Tetra Tech Coffey – Geotech Scope North Construction Traffic Management Plan

Sydney Metro Western Sydney Airport Station Boxes and Tunnelling Works

Project number	WSA-200-SBT
Document number	SMWSASBT-CPG-SWD-SW000-TF-PLN-000002
Revision date	05/04/2023
Revision	Rev 02

FW: Conditional Approval: SMWSA - SBT - Geotech Scope North (Addendum - Appendix 5)

Date: 15/3/2022	Project: SBT-GW-1005	CLIENT: Tetra Tech Coffey	PLAN No: WSA010
ROAD/SUBURB:	SBT-GW-1005, 5 Letherbridge Street, St Marys - WSA010 - V3	Rev: V3	
CROSS STREET:	Phillip St		
ROAD SPEED	50km		
ROAD TYPE:	2 Lane 2 way		
OPERATION:	Dayworks		
AUTHORITY:	Penrith City Council

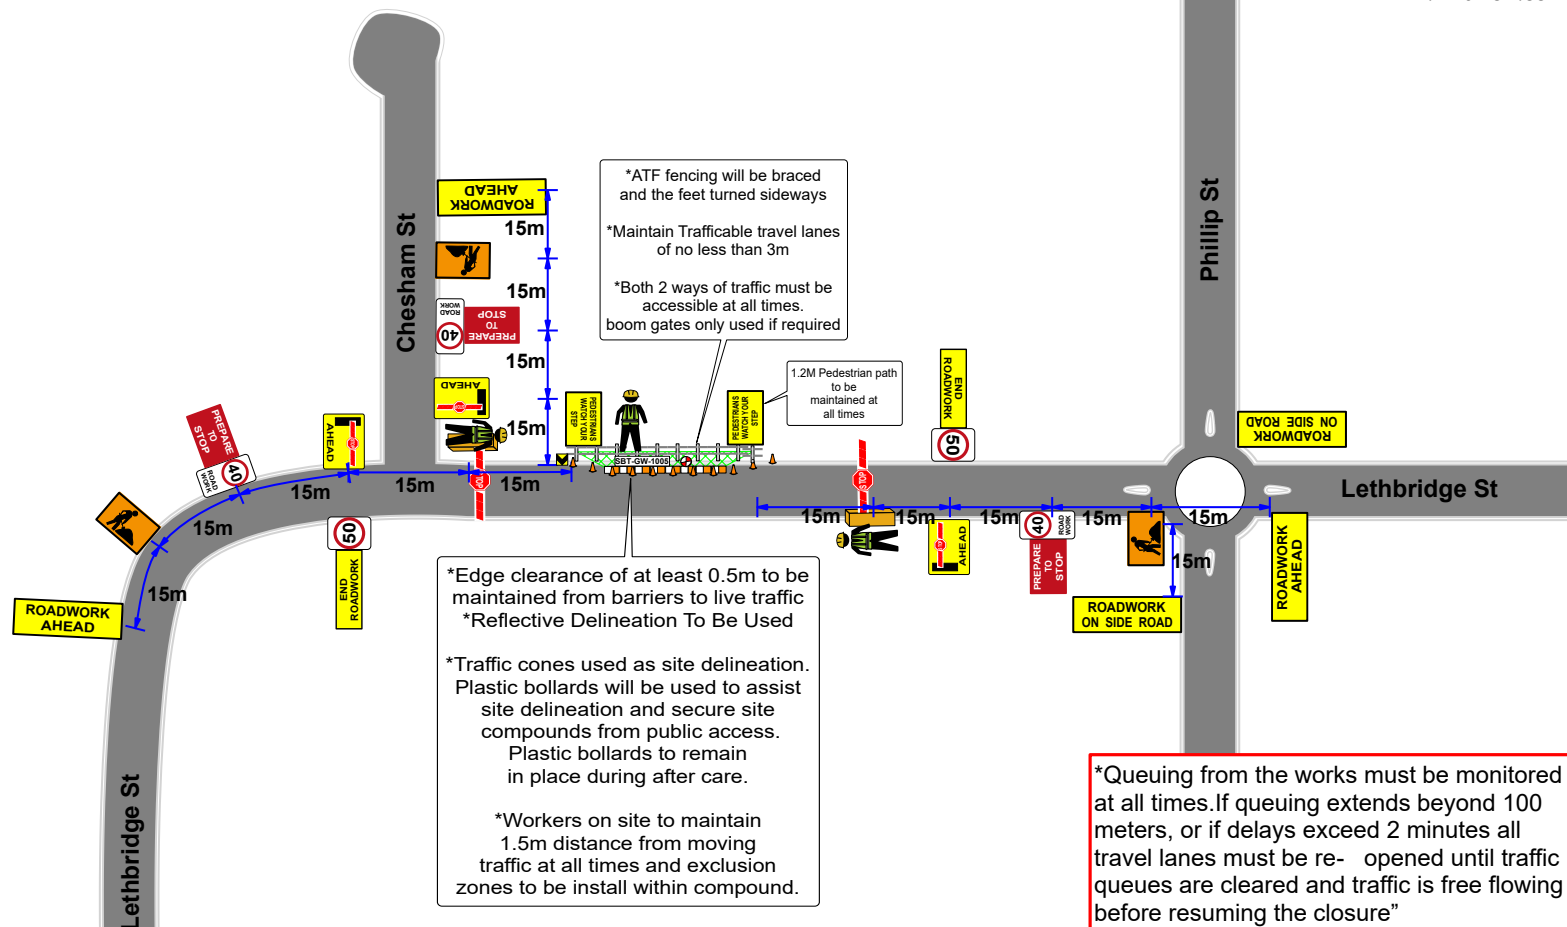
Table 4.2: Road Safety Audit Findings – Lethbridge Street Southbound Parking Lane Closure (WSA010)

Date: 7/7/2022	Project: SBT-BH-1023	CLIENT: Tetra Tech Coffey	PLAN No: WSA063
ROAD/SUBURB:	SBT-BH-1023, Gipps St and Werrington Rd, Werrington - WSA063 - V1		
CROSS STREET:	The Kingsway		
ROAD SPEED	60km		
ROAD TYPE:	2 Lane 2 way		
OPERATION:	Dayworks		
AUTHORITY:	Penrith City Council

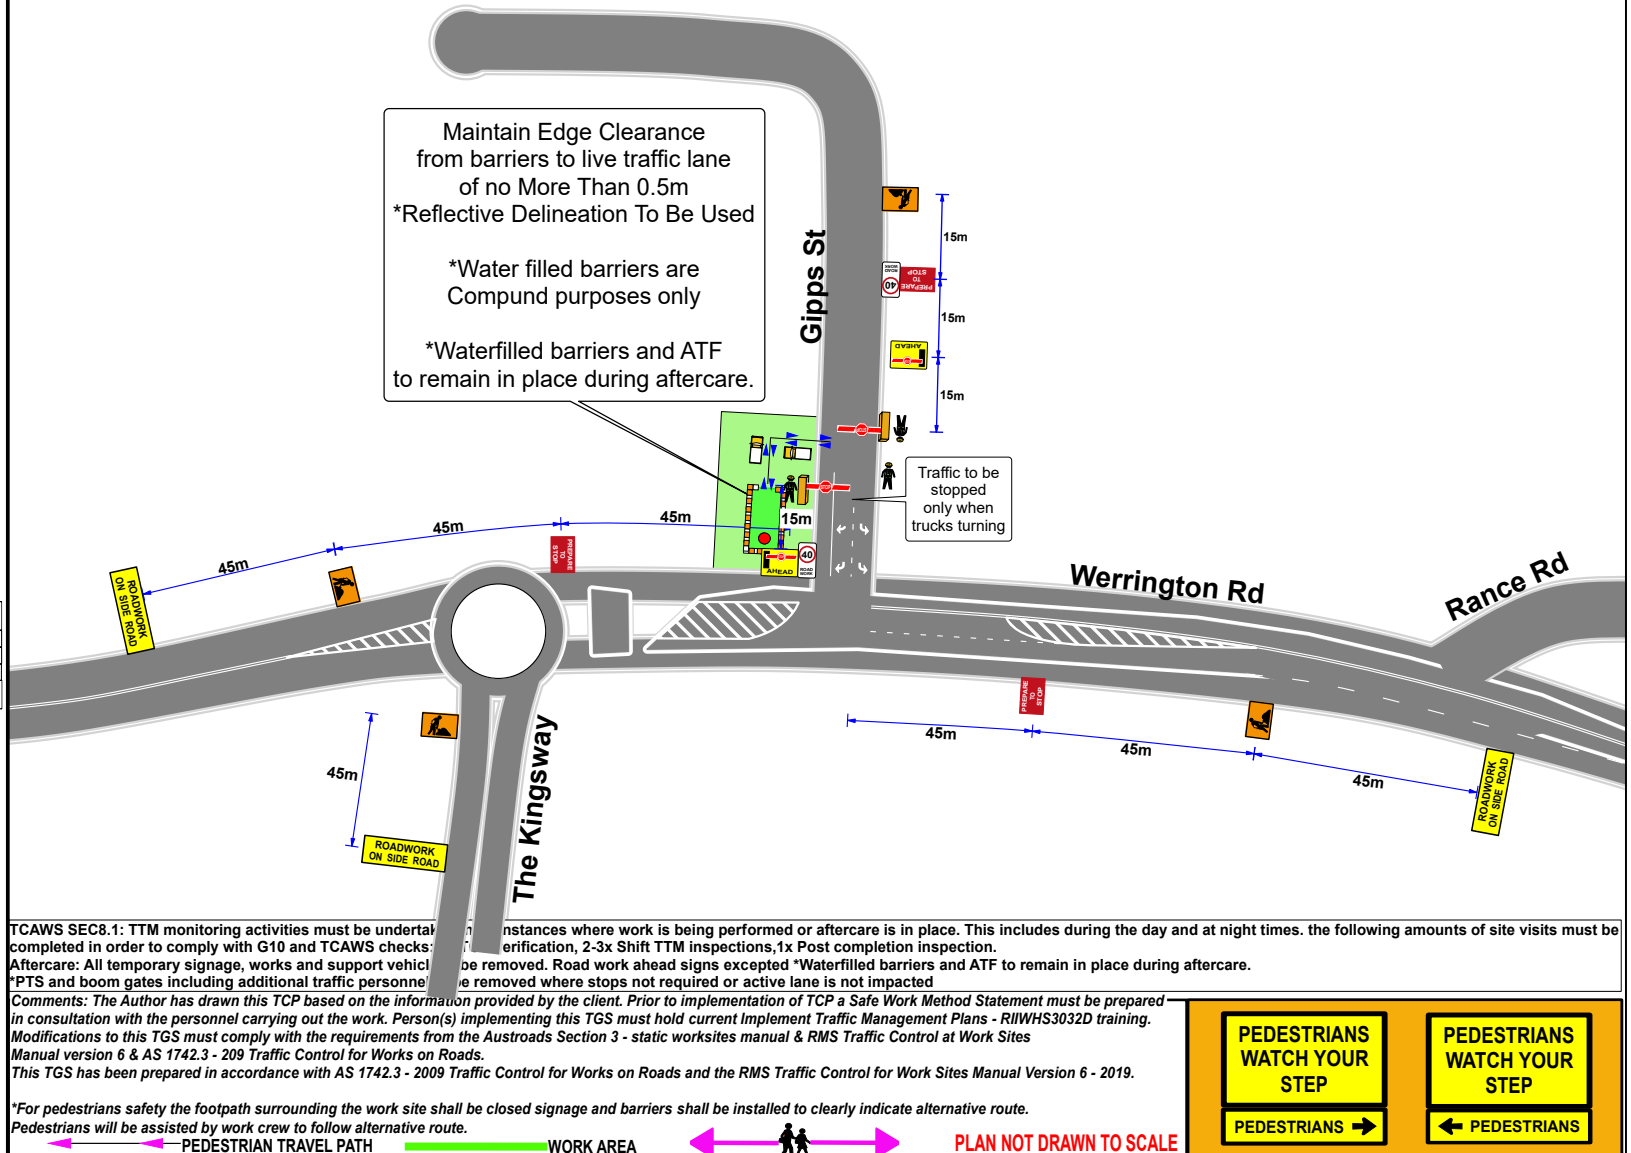
Item No.	Location	Descriptions of Findings	Design	Likelihood	Severity	Risk Rating	CPG JV Response
WSA063-1	Gipps Street northbound	<p>TCaWs requires TGS to show the predicted end-of-queue length but this is not provided in accordance with TCaWS Section 7.4.1.</p> <p>A school is located at the end of Gipps Street and therefore the traffic volume would be relatively high before and after school hours.</p> <p>Portable boom barriers are located a short distance from the Werrington Road intersection. If the rear of the queue extends into the intersection, this may be clipped by a passing vehicle.</p>		Highly probable	Minor	Low	
WSA063-2	Gipps Street	<p>The 40km/h roadworks speed limit sign is not duplicated and is not compliant with TCaWS Section 4.5.5.</p>		-	-	Note only

Item No.	Location	Descriptions of Findings	Design	Likelihood	Severity	Risk Rating	CPG JV Response
WSA063-3	Gipps Street	There is no provision of an End Road Work sign and 50km/h speed zone sign on Gipps Street and is not compliant with TCaWS Section 4.5.5.	<p>earance traffic lane n 0.5m 1 To Be Used</p> <p>iers are ses only</p> <p>s and ATF ing aftercare.</p> 	-	-	Note only

Date: 7/7/2022	Project: SBT-CM-1029	CLIENT: Tetra Tech Coffey	PLAN No: WSA064
ROAD/SUBURB:	SBT-CM-1029 Gipps St, Claremont Meadows - WSA064	Rev: V1	
CROSS STREET:	Sunflower Dr		
ROAD SPEED	70km		
ROAD TYPE:	Multilane		
OPERATION:	Dayworks		
AUTHORITY:	Penrith City Council

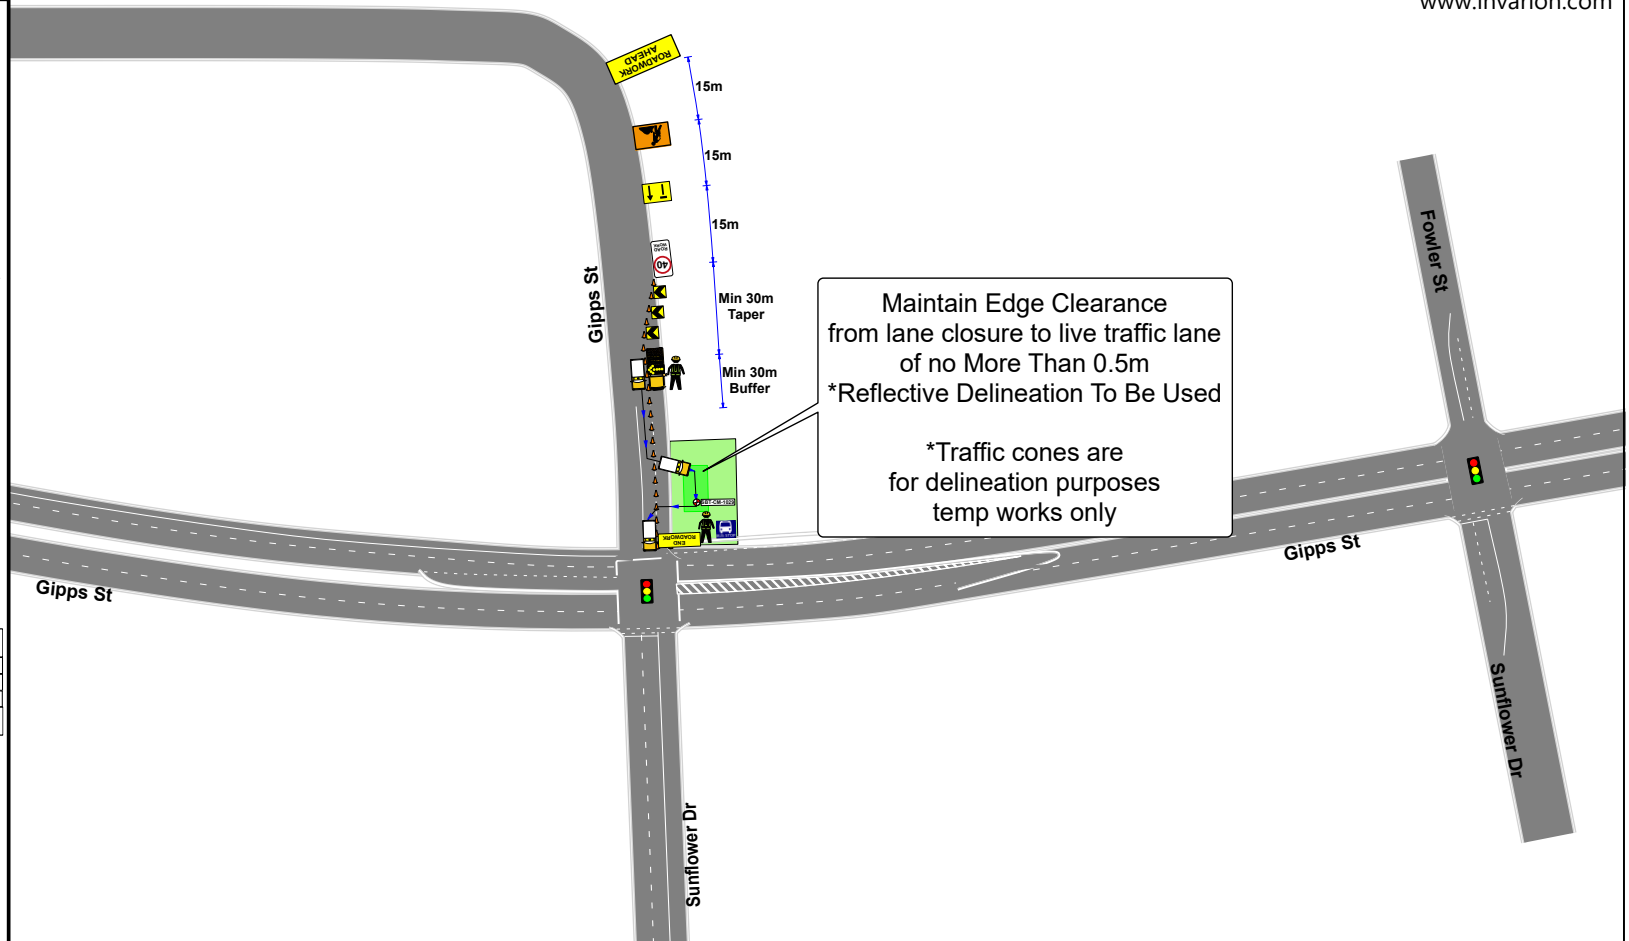
Table 4.5: Road Safety Audit Findings – Gipps Street Single Westbound Turning Lane Closure (WSA064)

Item No.	Location	Descriptions of Findings	Design	Likelihood	Severity	Risk Rating	CPG JV Response
WSA064-1 Deleted	Gipps Street	The 40km/h roadworks speed limit sign is not duplicated and is not compliant to TCaWS Section 4.5.5.		-	-	Note only	Location has been deleted, no longer required
WSA064-2 Deleted	Gipps Street	The TGS does not provide a pre-existing 50km/h speed limit sign on Gipps Street prior to or adjacent to the End Roadwork sign, in accordance with TCaWS Section 4.5.5.		-	-	Note only	Location has been deleted, no longer required

Date: 8/7/2022	Project: SBT-BH-1033	CLIENT: Tetra Tech Coffey	PLAN No: WSA066
ROAD/SUBURB:	SBT-BH-1033, 57 Blackwood Street, Claremont	- WSA066 - V1	Rev: V1
CROSS STREET:	Caulfield Rd		
ROAD SPEED	50km		
ROAD TYPE:	2 Lane 2 way		
OPERATION:	Dayworks		
AUTHORITY:	Penrith City Council

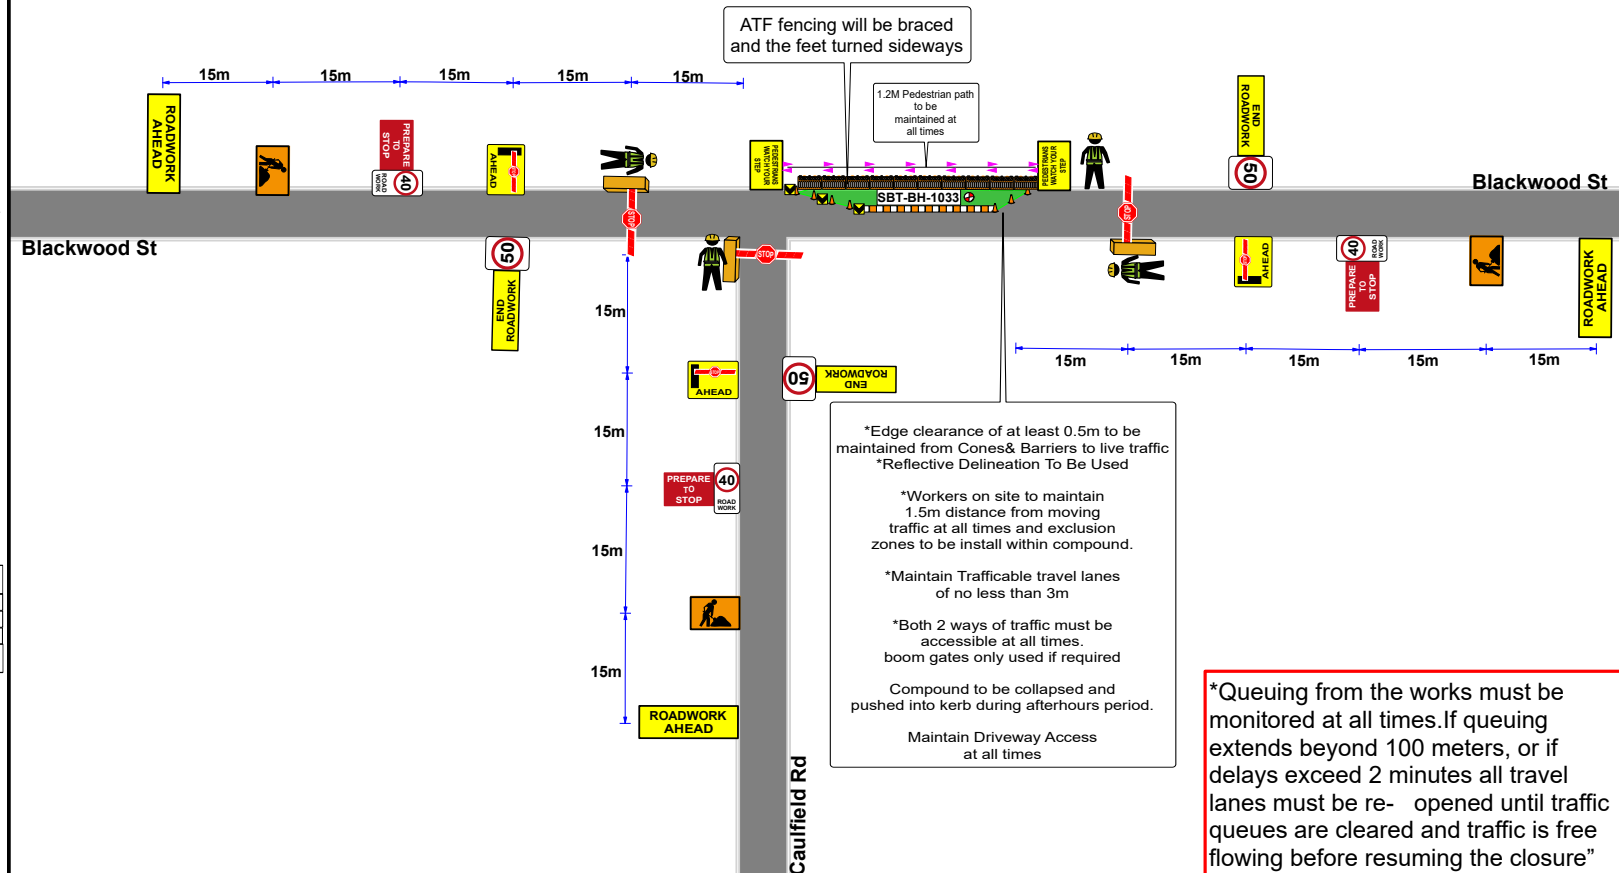
WSA066-3	General	TCaWs requires TGS to show the predicted end-of-queue length but this is not provided in accordance with TCaWS Section 7.4.1.	-	-	-	Note only

Item No.	Location	Descriptions of Findings	Design	Likelihood	Severity	Risk Rating	CPG JV Response
WSA066-4	59 Blackwood Street	The work site impedes driveway access to property 59 Blackwood Street, located just north the Blackwood Street and Caulfield Road intersection. There is no mention in the TGS nor the CTMP how property access is to be managed. It is unclear how motorists will enter and exit a residential home located within the work area.	 <p>ATF fencing will be braced and the feet turned sideways</p> <p>1.2M Pedestrian path to be maintained at all times</p> <p>PEDESTRIANS WATCH YOUR STEP</p> <p>SBT-BH-1033</p> <p>STOP</p> <p>Blackwood St</p> <p>Caulfield Rd</p>	-	-	Note only	<p>The compound will be located between the two driveways indicated. Access for residents will be maintained at all times</p> <p>Note already included that driveways will not be blocked in current TGS</p>
